FINAL PLAT OF
"BOSLEY'S FIRST ADDITION"
WICHITA, SEDGWICK COUNTY, KANSAS
IN THE SW 1/4 OF SECTION 9, T28S, R1E OF THE 6TH P.M.

RE: SUB 2000-64 -- One-Step Final Plat of BOSLEY'S FIRST ADDITION

RE: SUB 2000-64 -- One-Step Final Plat of BOSLEY'S FIRST ADDITION

CASE NUMBER: SUB 2000-64 -- BOSLEY'S FIRST ADDITION

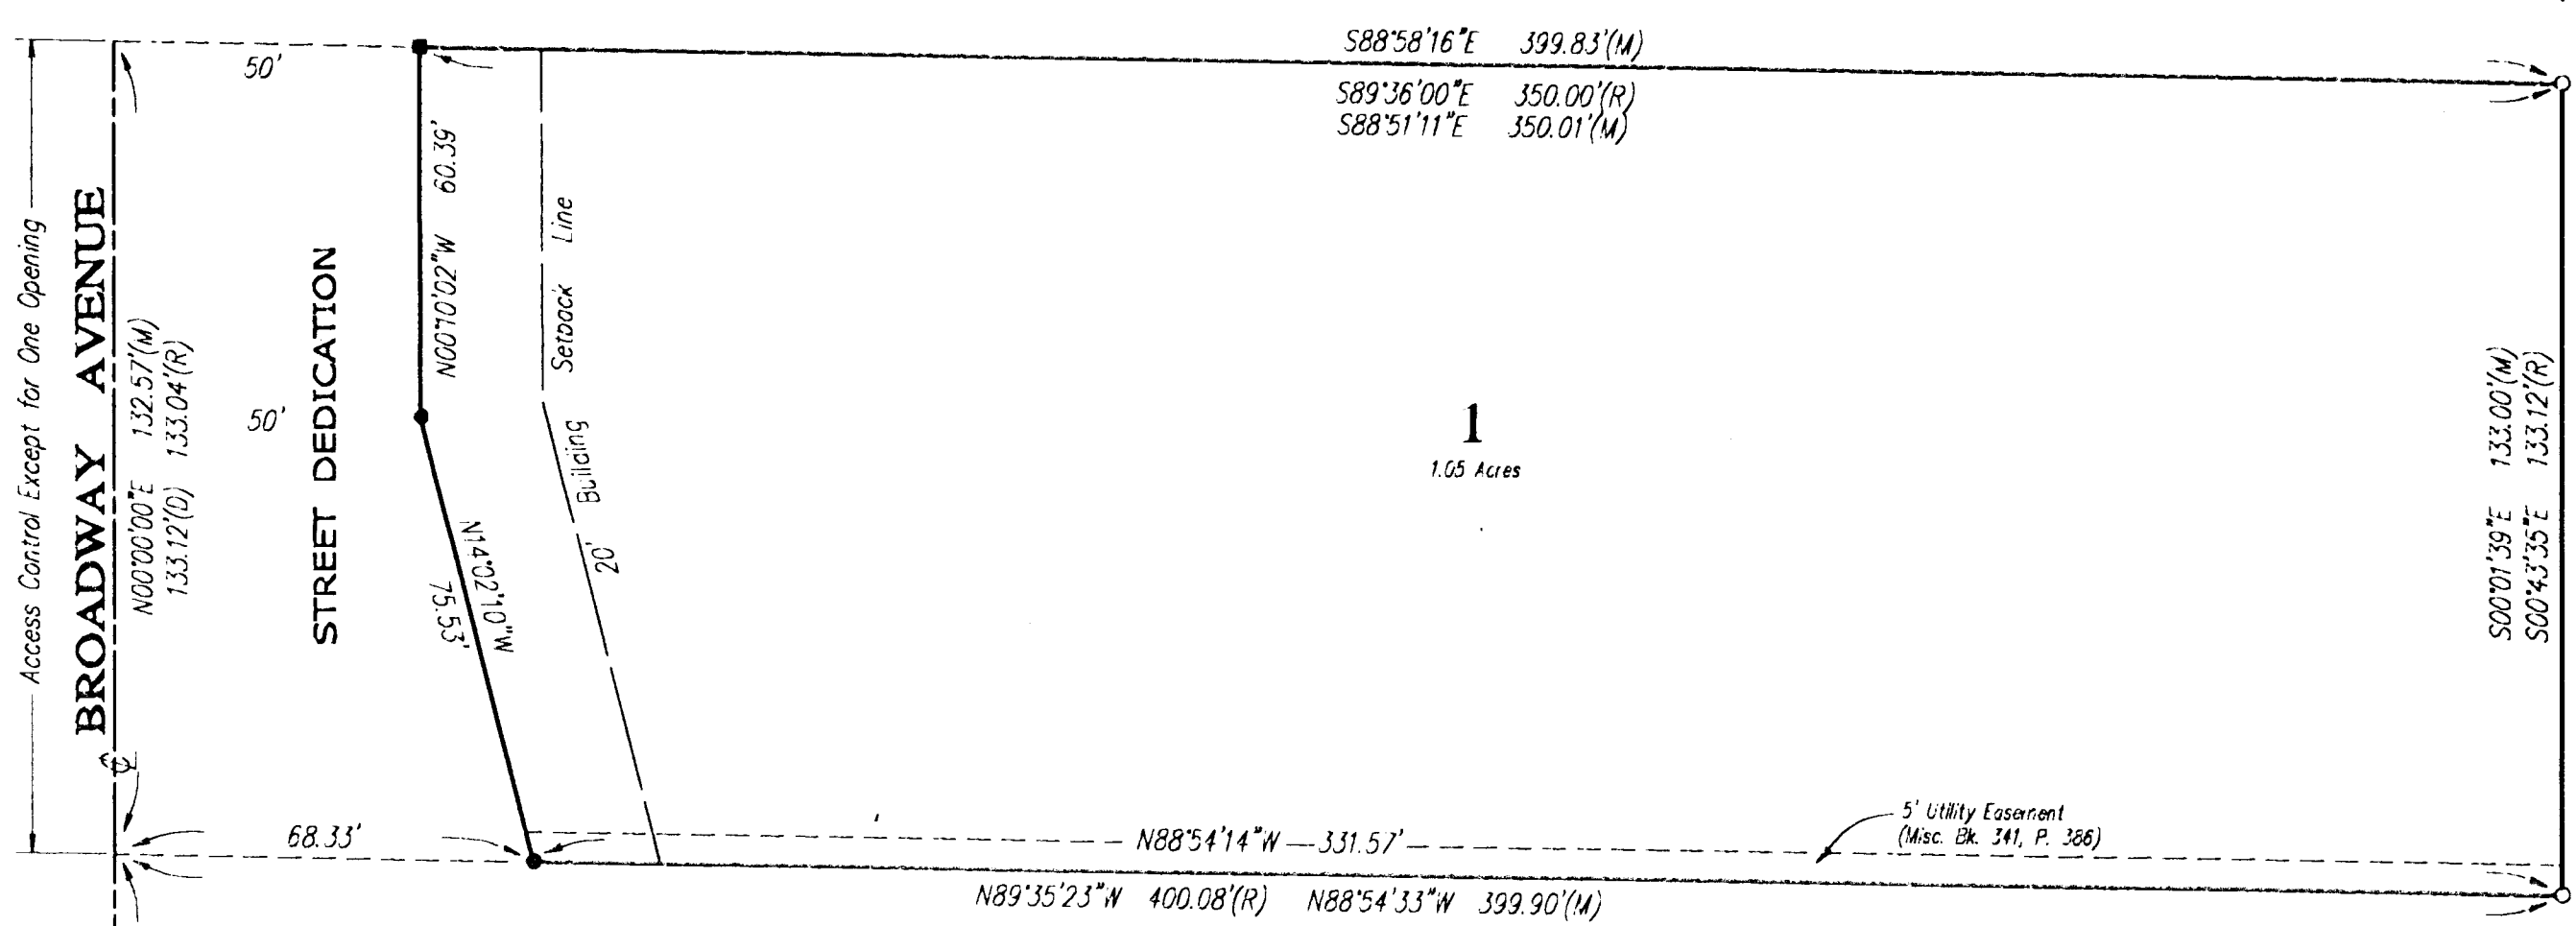
- A. Municipal services are available to serve the site. City Engineering needs to comment on the need for any guarantees or easements. No guarantees are required.

- C. City Engineering needs to comment on the status of the applicant's drainage plan. The drainage plan needs to be revised.
- D. Traffic Engineering should comment on the need for access controls. In accordance with the Subdivision regulations, any access openings located within 250 feet of the intersection of Broadway and MacArthur are limited to right-turns only, and shall be referenced on the face of the plat; or a guarantee provided for the future construction of a raised medial. The final plat shall reference the access controls in the plat's text. Access control except for one opening is required.

- E. The applicant shall guarantee the closure of any driveway openings located in areas of complete access control or that exceed the number of allowed openings.

- F. If platted, the building setback may be established at a minimum of 20 feet to conform with the GC District zoning standards.

- I. The platting text shall include language that a drainage plan has been developed for the plat and that all drainage easements, rights-of-way, or reserves shall remain at established grades or as modified with the approval of the applicable City or County Engineer, and unobstructed to allow for the conveyance of stormwater.

- K. The applicant's engineer is advised that the Register of Deeds is requiring the name(s) of the notary public, who acknowledges the signatures on this plat, to be printed beneath the notary's signature.

- O. Perimeter closure computations shall be submitted with the final plat tracing.
- P. Recording of the plat within thirty (30) days after approval by the City Council and/or County Commission.
